Bioenergy with Carbon Capture and Storage (BECCS) at Drax Power Station

Proposed Changes Consultation Booklet
21 October – 20 November 2022

Location of Proposed Change Order limits and proposed Floodplain Compensation Area (FCA)

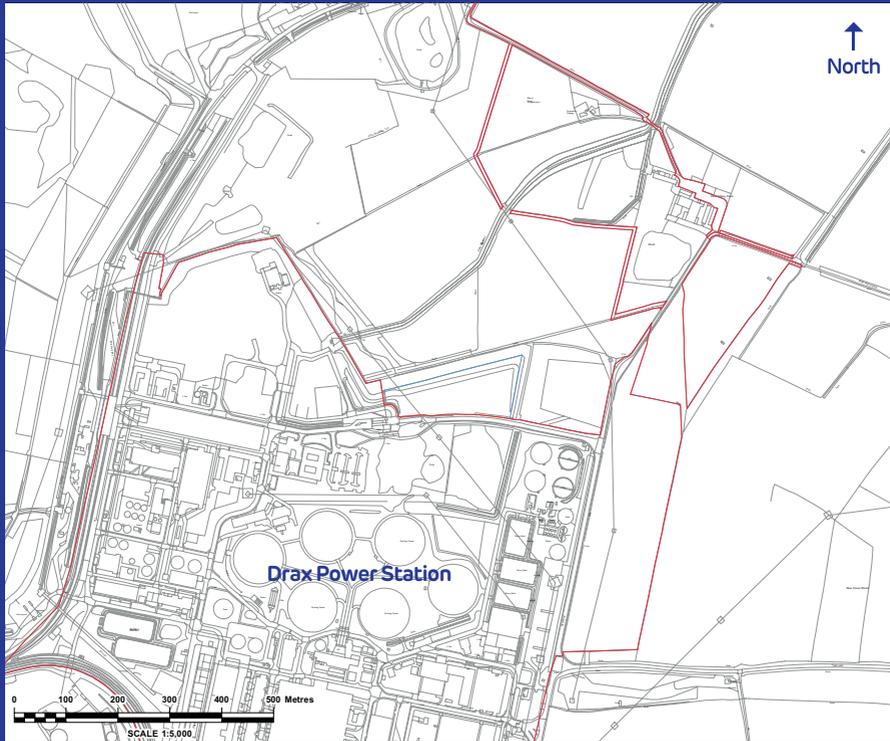
Proposed Change PC-01 is required to mitigate against the slight loss of floodplain which arises as a result of the Scheme. Within the submitted Application* Drax committed to providing additional floodplain capacity (a minimum floodplain area of 1,889 m² will be created) through the lowering of ground currently outside the floodplain on land controlled by Drax. This land is referred to as the Floodplain Compensation Area (FCA).

The location of the proposed FCA works has now been finalised and is shown on the plan below. The land is owned by Drax and is currently use for grazing purposes by an agricultural tenant. The site of the

proposed FCA works comprises a field on the north of the Drax Power Station Site and would be subject to engineering operations to lower the north section of the existing ground levels to provide land which will be allowed to flood where necessary to provide additional floodplain capacity. It is anticipated that the material to be excavated to provide the FCA will be relocated to the southern section of the field, and the site landscaped to provide appropriate gradients of slope.

The works to create the FCA would be temporary in nature, and after the works have been completed and the ground level has been permanently lowered, the ground cover would be reinstated as grassland.

OHL proposed pole works – A645/A614 Rawcliffe Road roundabout

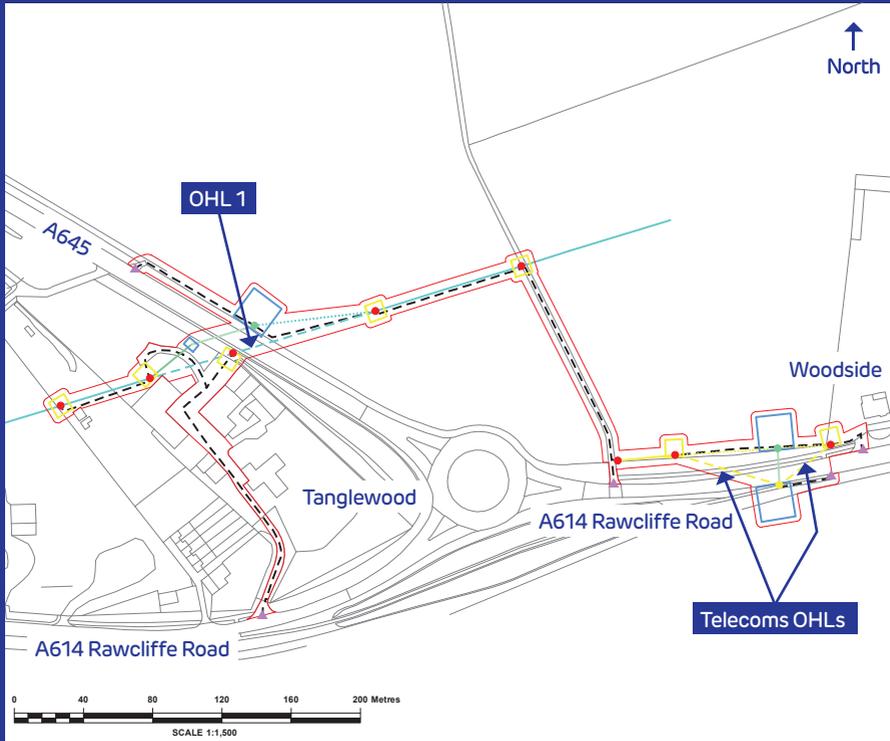
Proposed Change PC-02 is required to facilitate the delivery of Abnormal Invisibile Loads (AILs) to the Site during the construction phase of the Proposed Scheme. The draft DCO submitted with the Application (document reference APP-013) seeks powers to replace or underground overhead power and telecommunications lines at certain locations which are identified on the Access and Rights of Way Plans (document reference APP-011) (ARoW Plans). These powers are sought because the loads carried as part of the multiple AIL movements would be taller than or interfere with the operation of two electrical and two telecommunications OHLs, causing a conflict.

Following submission of the Application, ongoing discussion with the owner of the two electrical OHLs (Northern Powergrid), regarding their preferred approach for dealing with this conflict identified that:

- Location '1' on sheet 4 of the ARoW Plans is in the incorrect location and the plan will need to be amended as part of the Proposed Change;
- Undergrounding is the preferred approach although the final design for the relocated assets may include an element of a slight realignment of the existing OHLs and restringing works;
- Undergrounding needs to take place for the section of the electrical OHLs which is supported by telegraph poles i.e. from 'pole to pole' rather than just for the section of OHL which sits over the highway. The poles which relate to the OHLs shown on the ARoW Plans are located outside of the highway boundary;

- Undergrounding of the electricity cables could be undertaken via horizontal directional drilling (HDD) or open trenching methods, as appropriate; and
- Third party land outside of Drax's ownership (known as 'additional land') would be required to access the poles and undertake the works. Furthermore, as the position of the electrical cables, be they undergrounded or realigned OHLs, may be different to the route of the existing OHLs, the DCO documentation will need to be updated to provide powers to enable the installation of the altered alignment of the electrical cabling (be they via undergrounded sections or OHLs), and to access and maintain the altered sections of electrical cabling in the future.
